Agenda
Village of Arlington Heights
Design Commission
Community Room, 3rd Floor

Item: DC#19-039 - 622 E. Mayfair Rd. - SF/Addition

STAFF DESIGN COMMISSION REPORT RE-REVIEW

Project Name: Carlson Residence
Project Address: 622 E. Mayfair Rd.
Prepared By: Steve Hautzinger

3 ELEVATION STUDY - PROPOSED
Scale: 1/8" = 1'

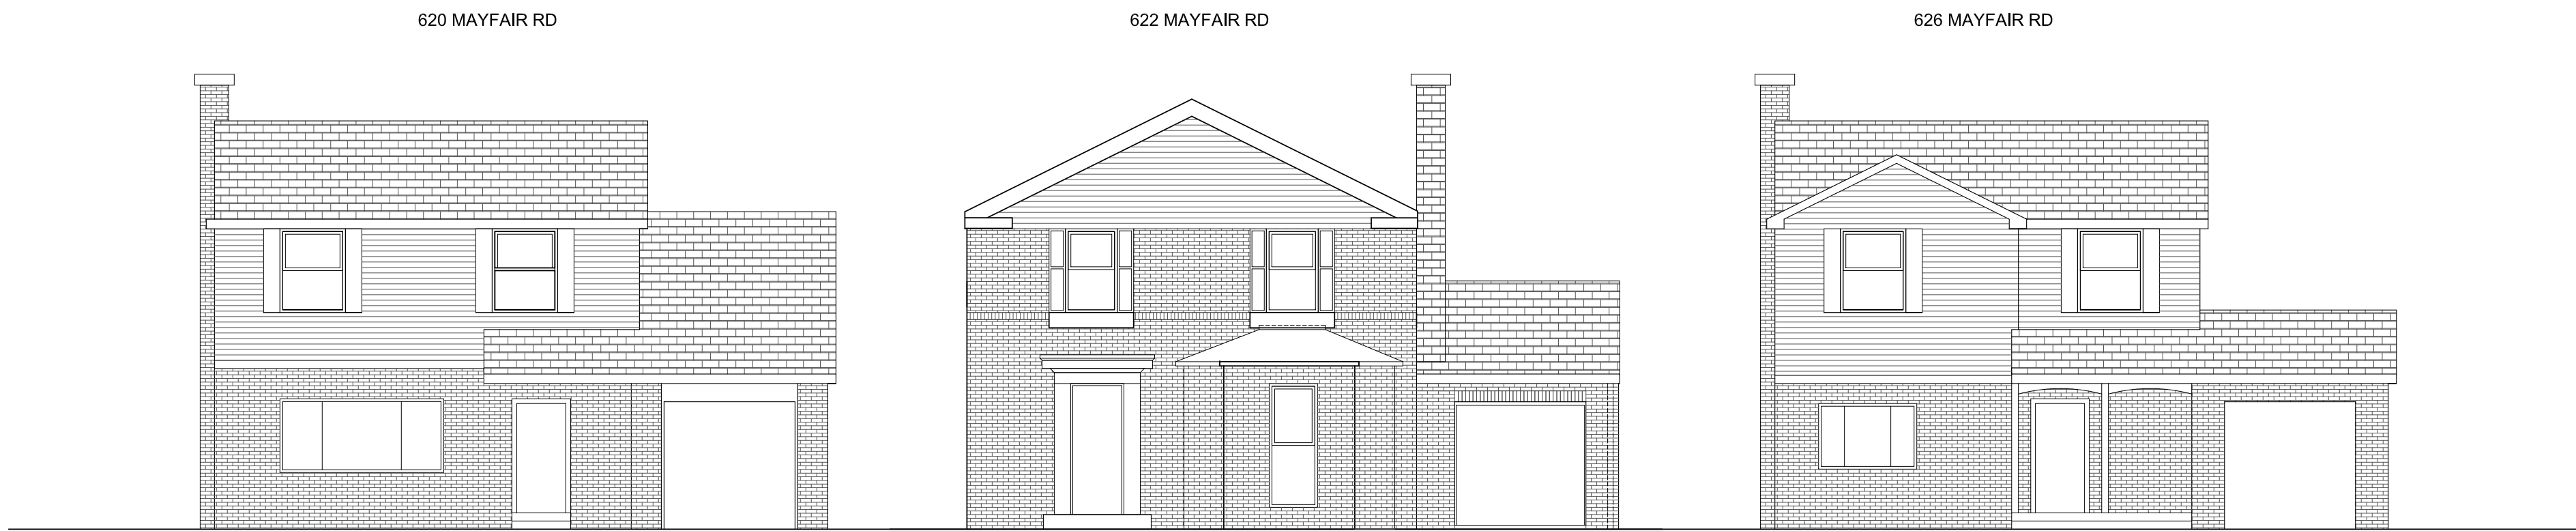
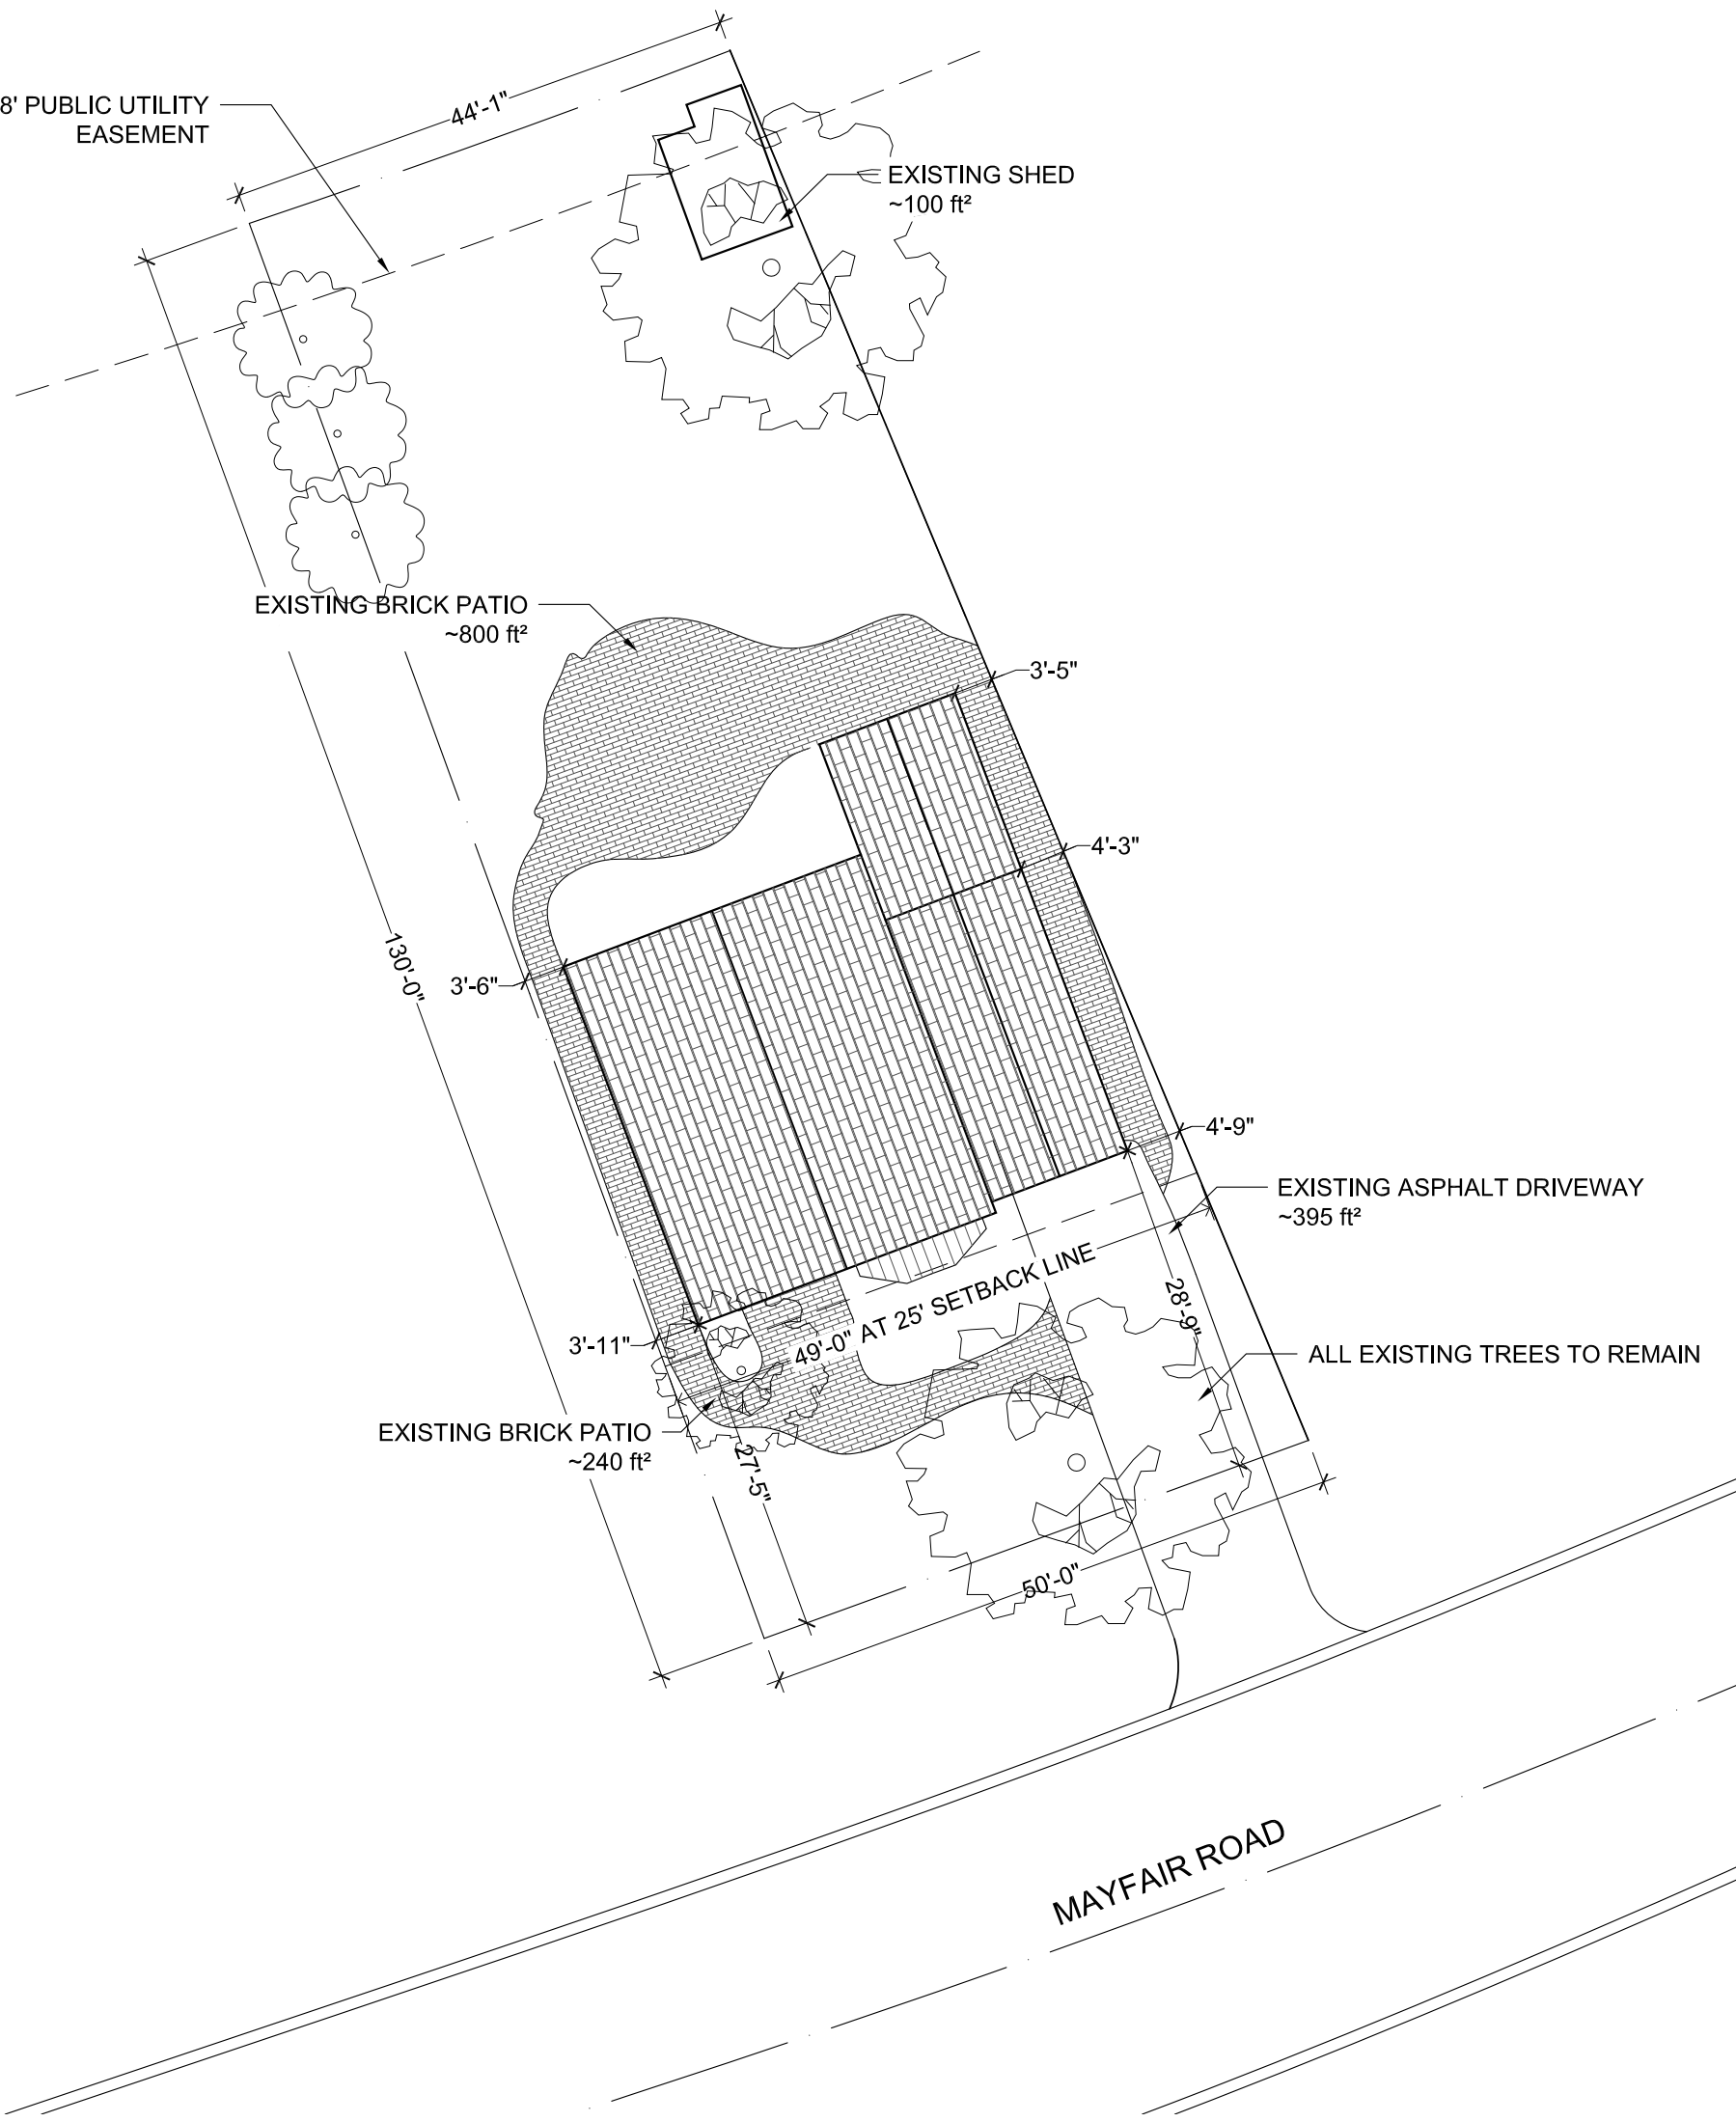
Overall, the changes have given the design a more subdued and traditional appearance that works much better with the existing house. The reduction in the depth of the cantilever has a much more conventional appearance that fits well with the overall design. The side elevation still has an odd appearance due to the random stucco material, modern windows, and lack of gutter/soffit/fascia, but the almond wall color matches the other walls and it will have limited visibility. The two gables coming together to form a valley still has an unconventional appearance, but it is less prominent due to the reduced depth of the cantilever. A front-to-back roof gable framing into the side of the existing gable roof is still recommended as shown in the sketch below.

1. Evaluate the random stucco material, modern windows, and lack of gutter/fascia on the side elevation.
2. A recommendation to change the roof to a front-to-back gable for a more conventional appearance.

4 NORTH ELEVATION
1/8" = 1'-0"

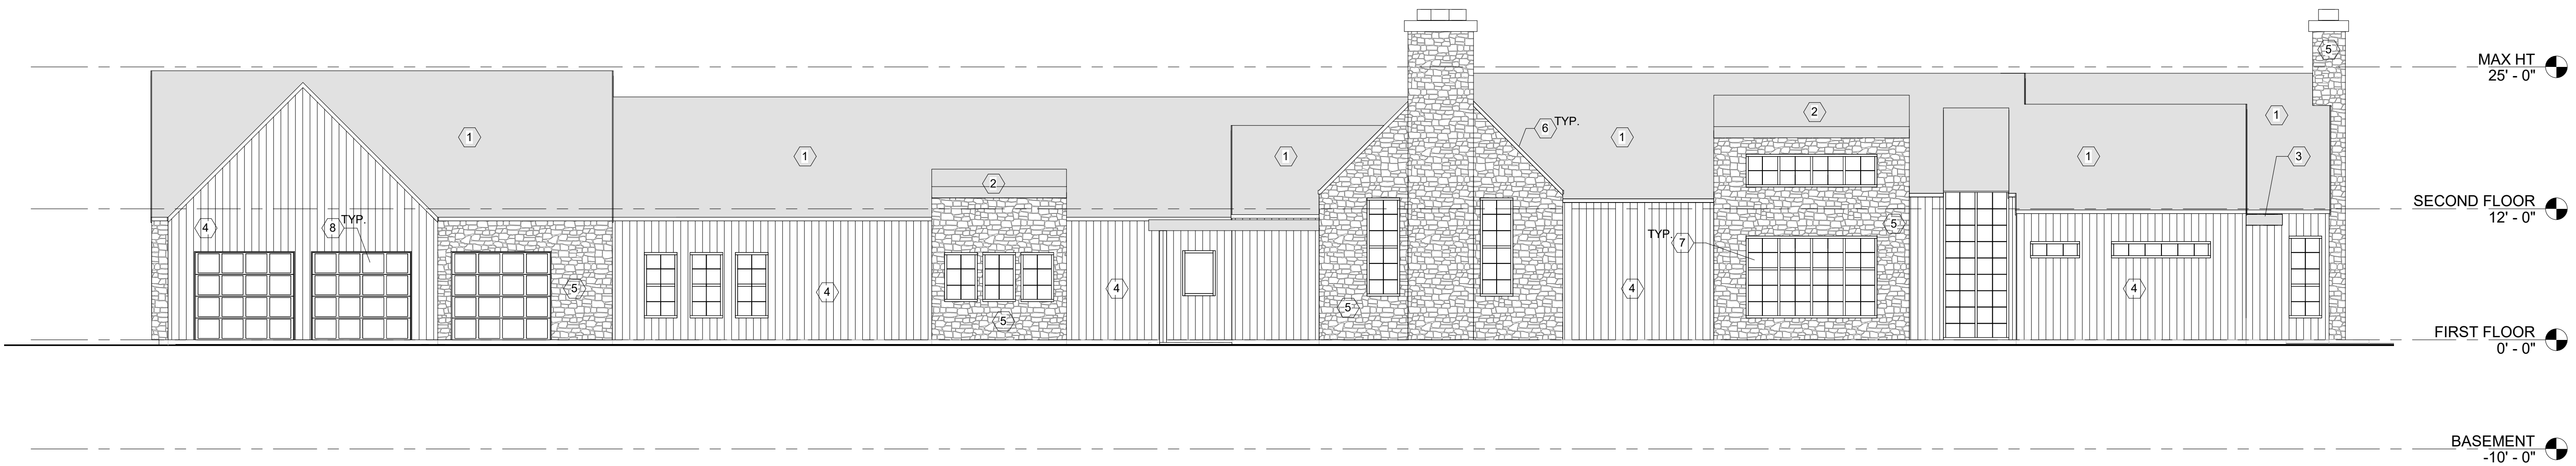
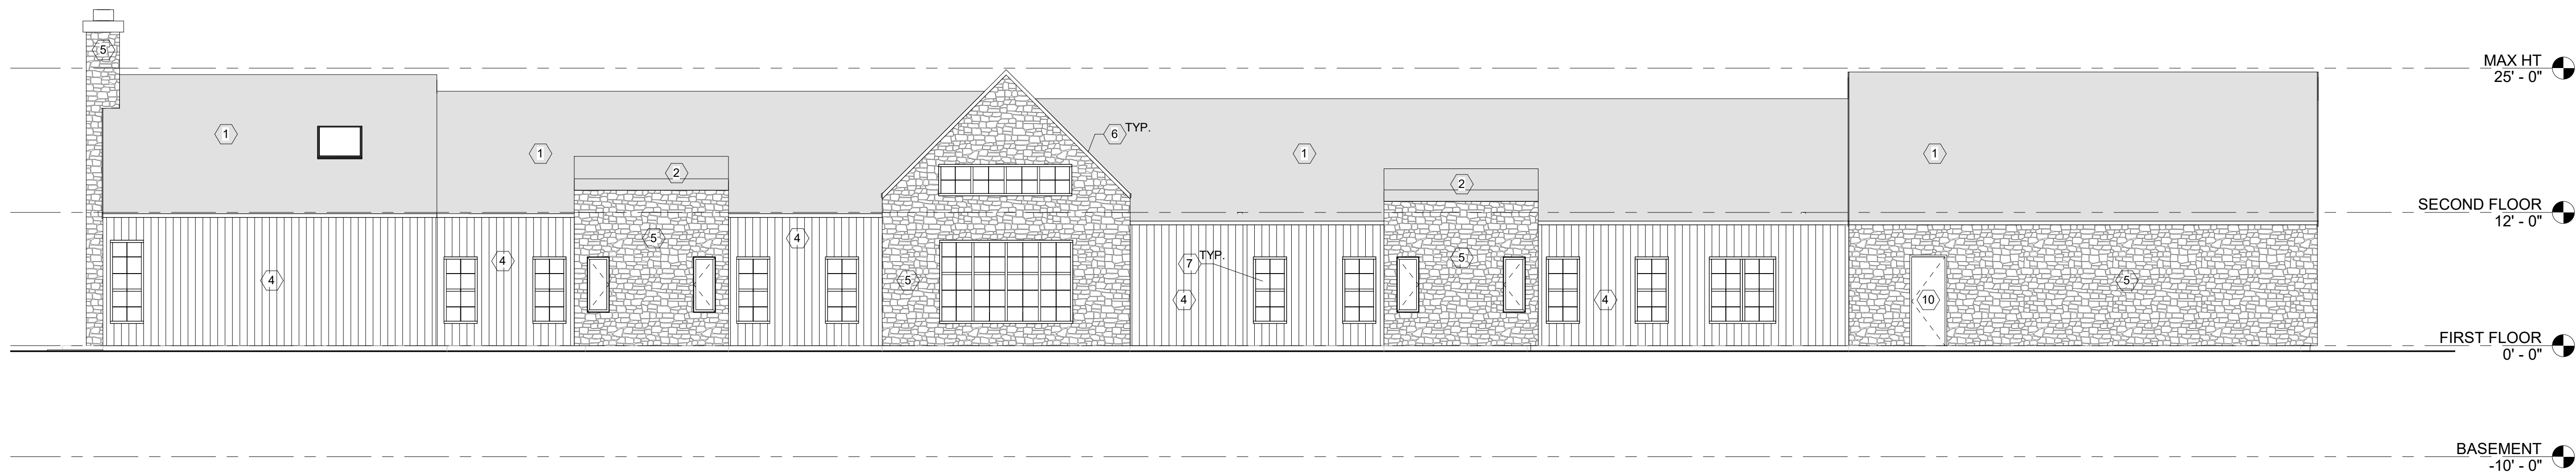
1. Consider a revised design with the garage moved closer to the front of the house to reduce the length of the north wall and driveway.
2. This review deals with architectural design only and should not be construed to be an approval of, or to have any other impact on, any other zoning and/or land use issues or decisions that stem from zoning, building, signage or any other reviews. In addition to the normal technical review, permit drawings will be reviewed for consistency with the Design Commission and any other Commission or Board approval conditions. It is the architect/homeowner/builder's responsibility to comply with the Design
